DUKE POWER COMPANY

Re: Catawba Nuclear Station
Docket Nos. 50-413 and 50-414

Confirmatory Issue (6)

SSI for buildings not founded on rock (SER Section 3.7.3)

FIGURE 10.1 ANALYSIS OF VERTICAL AMPLIFICATION

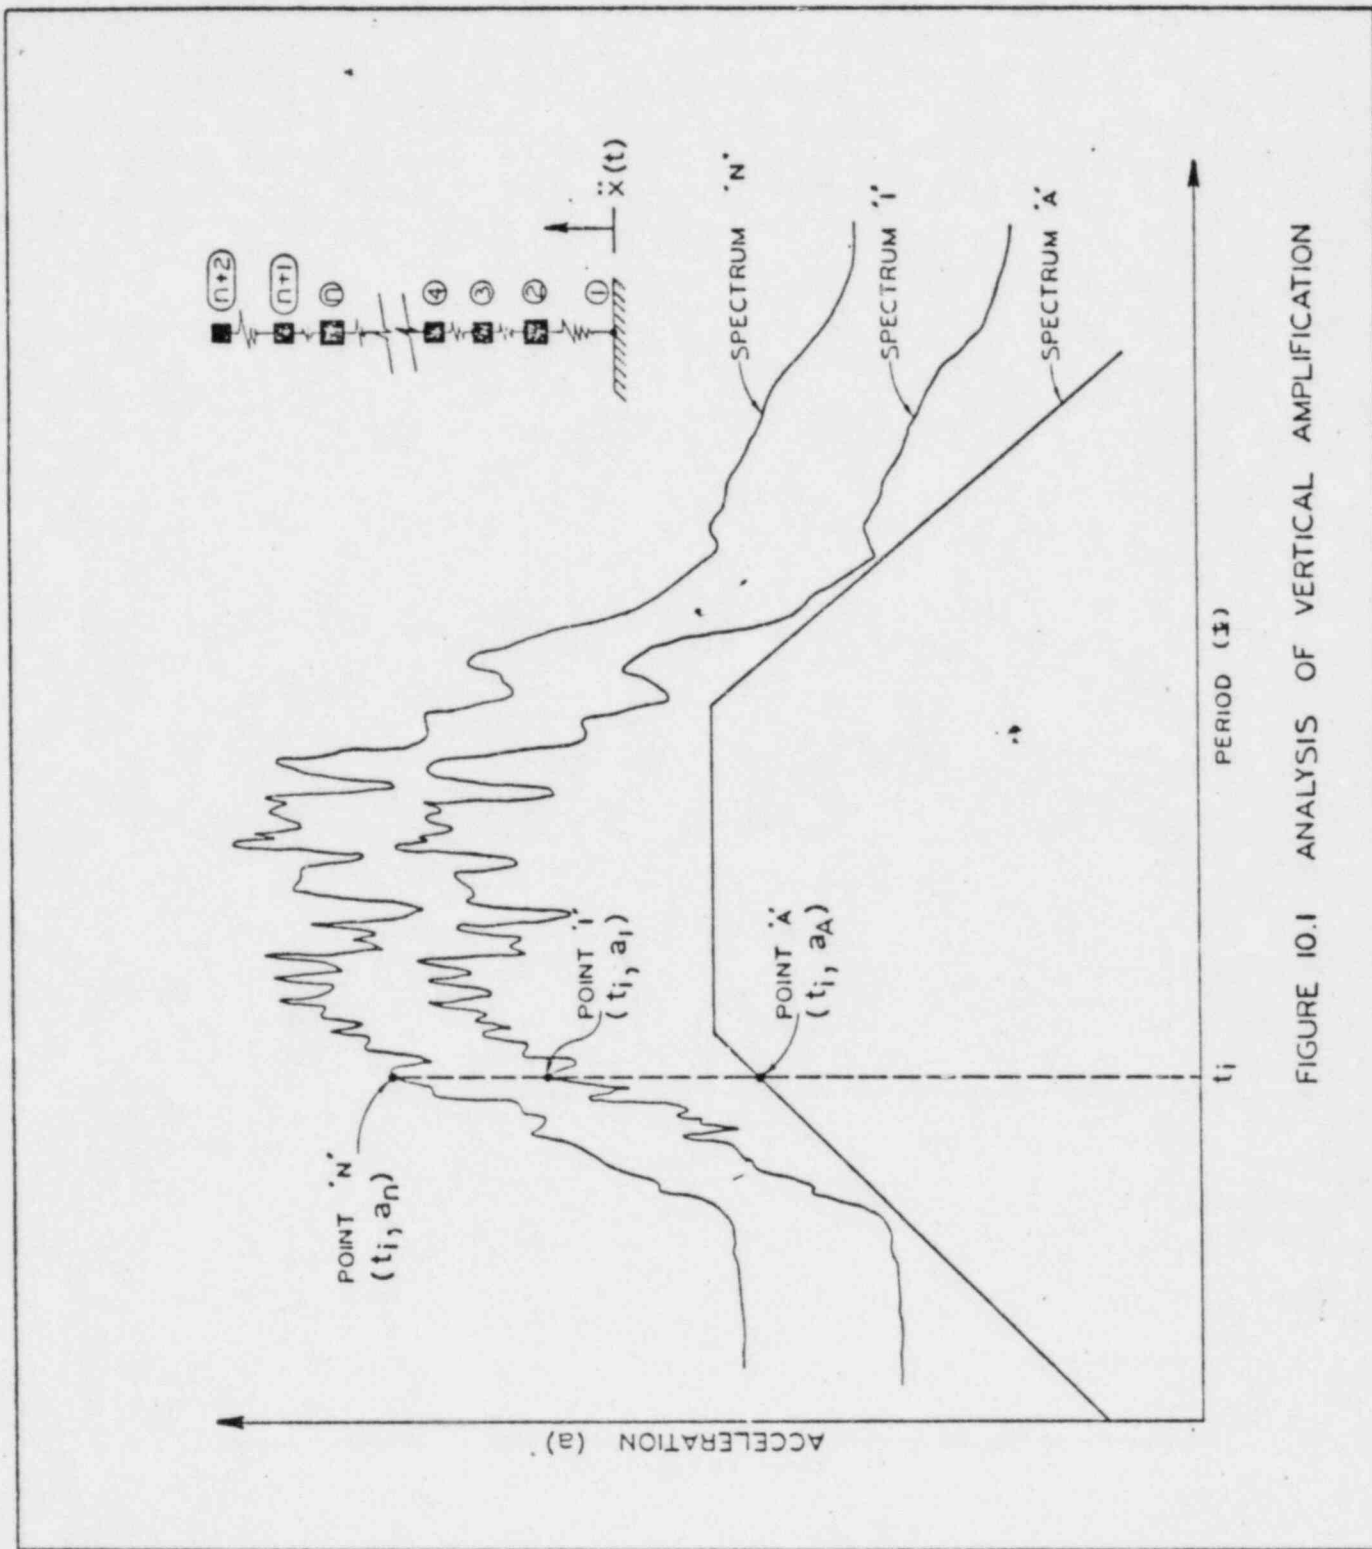
10. Provide justification demonstrating negligible amplification assumed in vertical seismic analysis (interior structure, auxiliary building, and steel containment).

A review of the results of the analysis described above was conducted to quantify the amplification in the vertical direction. Figure 10.1 depicts the methodology used in this review. In this figure, Spectrum "A" represents the required vertical ground response spectrum, defined in the FSAR as two-thirds of the horizontal ground response spectrum. Spectrum "1" represents the vertical ground response spectrum resulting from the input vertical base acceleration time history. It should be noted that this spectrum envelopes the horizontal ground response spectrum shown in the FSAR. Spectrum "n" represents the vertical response spectrum obtained at mass point "n". At a given period t_i , one point on each spectrum is defined.

For a given frequency or period, the magnification factor H was defined to be the ratio of the response acceleration to the excitation acceleration.

The digital response spectrum data was reviewed for all frequencies between 0 hz and 33.3 hz and for all applicable damping ratios. In the general frequency range of 5 hz to 20 hz, the magnification factor H was found to be greater than 1.05, indicating a 5% or greater amplification of the acceleration input at the base. At some points, the value of H reached a maximum of 1.51, indicating an amplification of the input acceleration by 51%.

Since this amplification was felt to be potentially significant, the spectrum data was further reviewed to quantify the magnitude of the acceleration increase. For an input vertical base excitation equal to the required vertical ground response (Spectrum "A"), the magnitude of the increase in acceleration is given by

FIGURE 10.2
CATAWBA NUCLEAR STATION
CONTAINMENT VESSEL
OBE VERTICAL RESPONSE AMPLIFICATION INVESTIGATION
DAMPING = 0.01

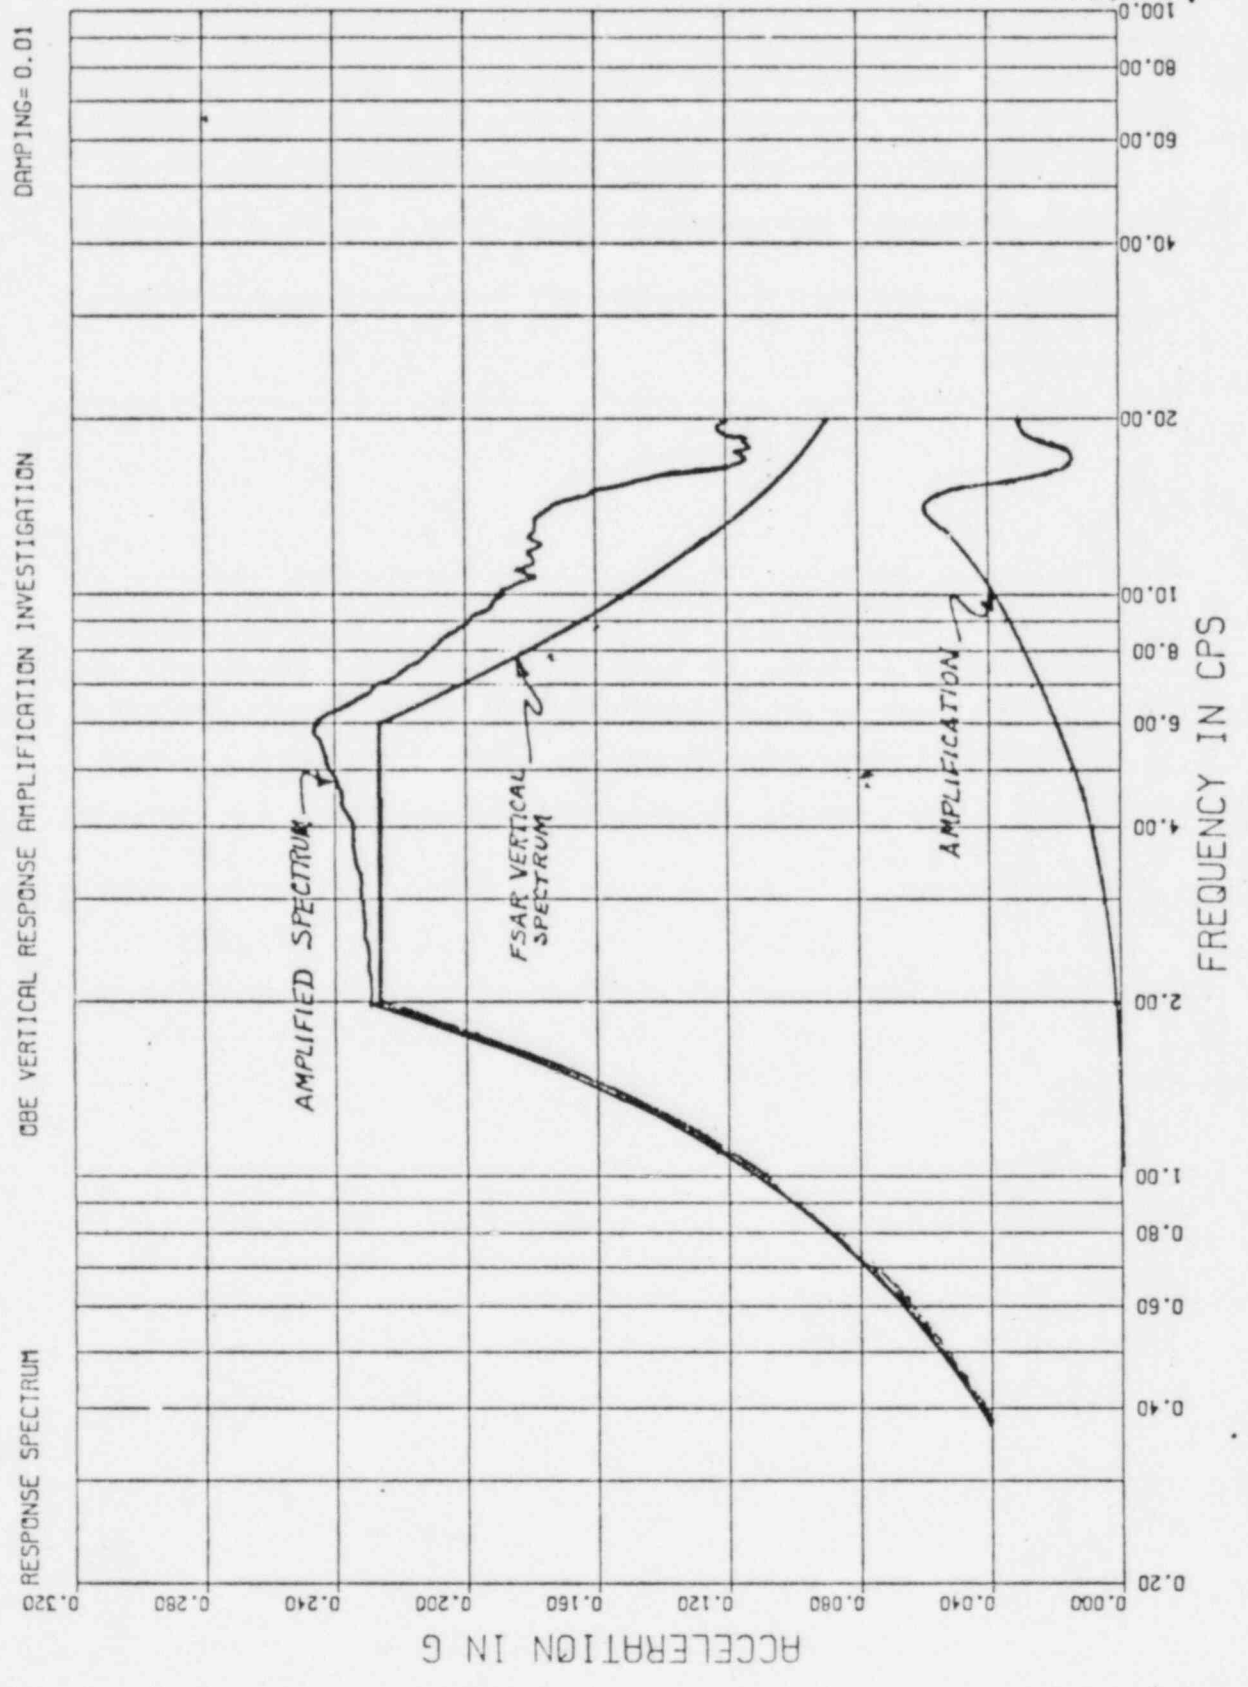
10. Provide justification demonstrating negligible amplification assumed in vertical seismic analysis.

Figure 10.2 graphically depicts the results of the analysis, showing a comparison of the FSAR vertical ground response spectrum, the amplified vertical spectrum at elevation 710'+11", and the amplification of the input vertical spectrum by the containment vessel. Figures 10.3 and 10.4 display the same information in tripartite format.

RELATIVE MAGNITUDE OF VERTICAL AND HORIZONTAL SPECTRA

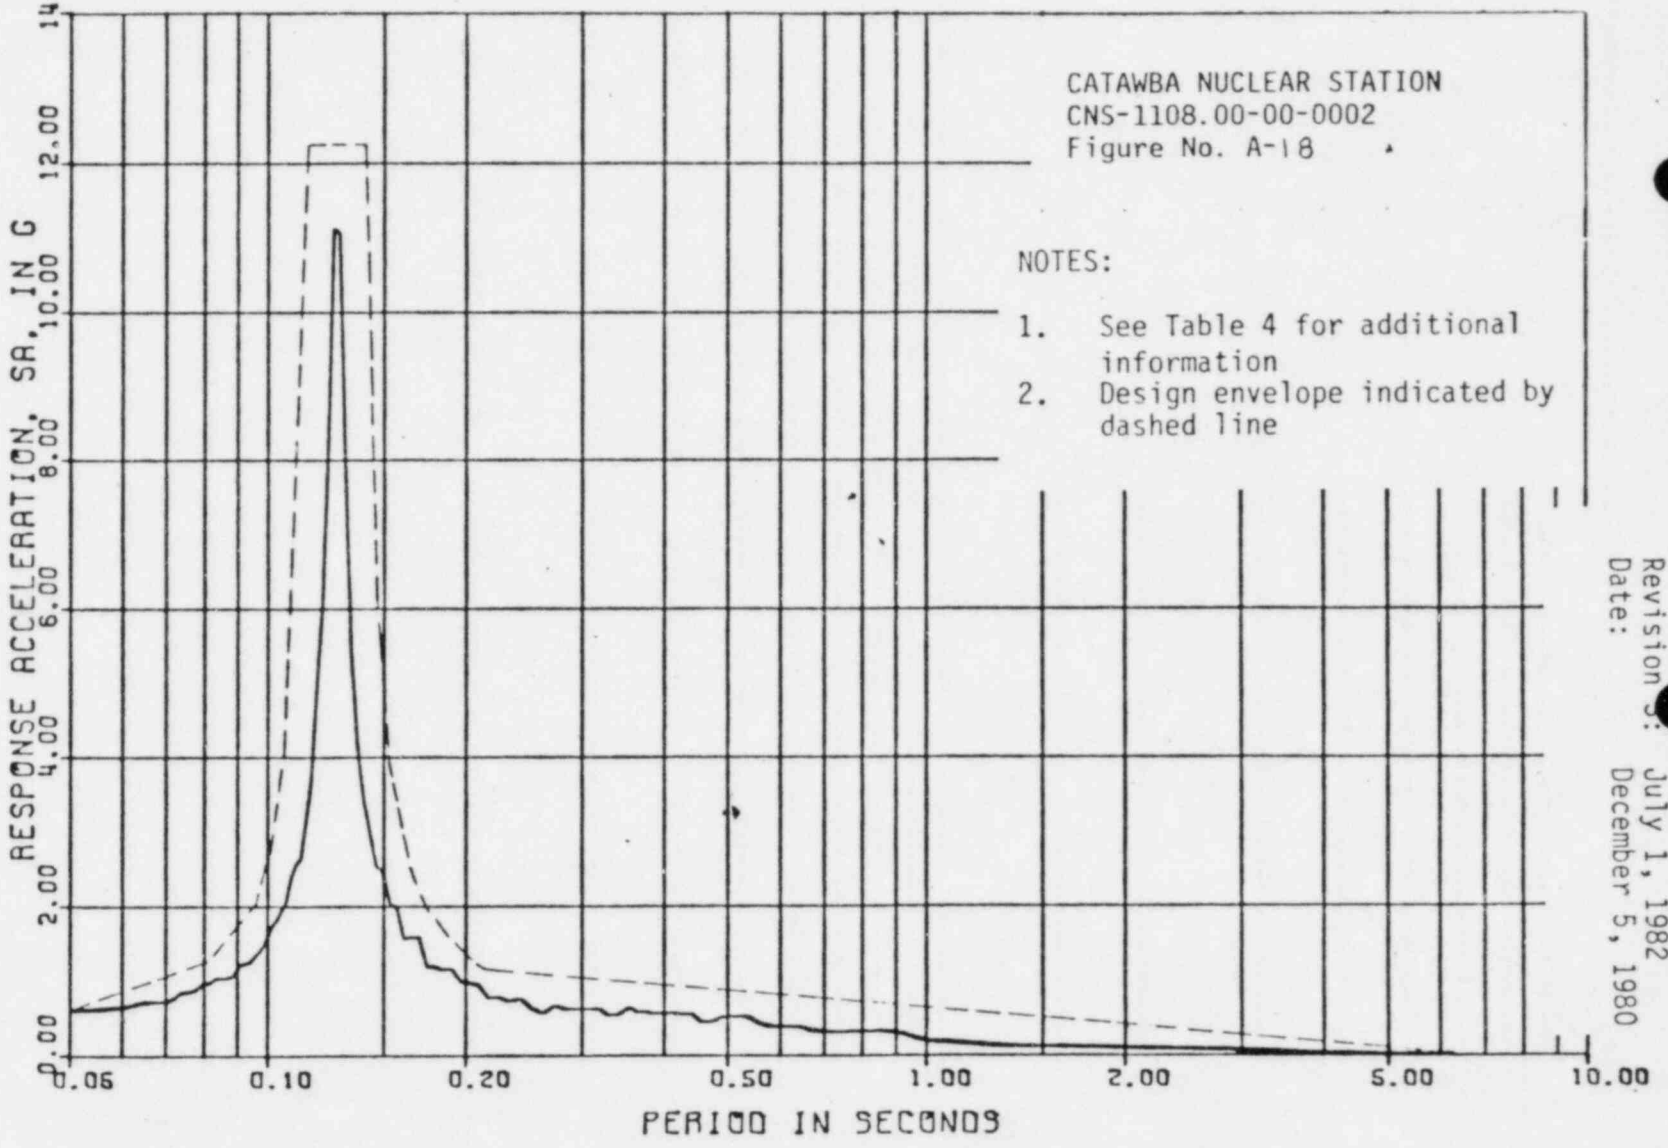
During the discussion of vertical amplification of seismic input, some discussion was raised over the relative magnitude of horizontal and vertical response spectra at one point.

For example, at the top of the dome, Figure A-18 of Specification CNS-1108.00-00-0002 (see next sheet) shows a peak acceleration level on the design envelope (10% above calculated spectrum) of approximately $12.2g$. At the same point, use of $\frac{2}{3}$ of the horizontal ground response spectrum applied in the vertical direction gives a design vertical acceleration of $0.23g$.

The purpose of this section is to address this apparent disparity and to show that it is in fact well founded.

WHEN THE STICK MODEL WAS ANALYZED IN THE VERTICAL DIRECTION FOR A VERTICAL ACCELERATION TIME HISTORY CORRESPONDING TO 100% OF THE HORIZONTAL GROUND RESPONSE SPECTRUM, THE MAXIMUM RESPONSE SPECTRUM ACCELERATION NOTED (FROM SPECTRUM "N", RUN "COMPARE" OR RUN "SPECTRA"), WAS 0.53g

THE RELATIVE MAGNITUDES OF HORIZONTAL AND VERTICAL RESPONSES ARE IN THE CORRECT PROPORTION TO ONE ANOTHER.
